## **New District Pond**

An additional pond, indentified as #48 on the Ponds Maintenance Report, has recently been added to the work load of the Harmony Field Services staff.

## **New District Pond**

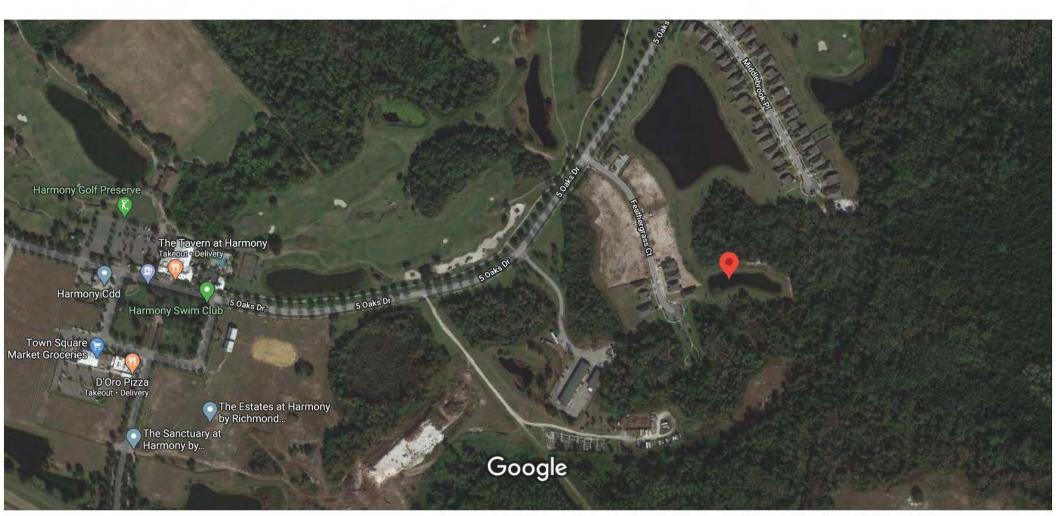
This pond is located off the lower end of the north-east side of *Feathergrass* in the "O" community (otherwise known as "*Waterside*") – see attached graphic.

To my knowledge, this pond has never been identified in any District Engineer documentation or presentation available to the Harmony CDD Board of Supervisors.

Confirmation is needed that this pond is indeed part of the Harmony Stormwater Management System, and is accordingly the responsibility of the District to maintain.

It is therefore required and requested that District Engineer, Steve Boyd, provide immediate updates to any and all affected documents so that appropriate action is taken.
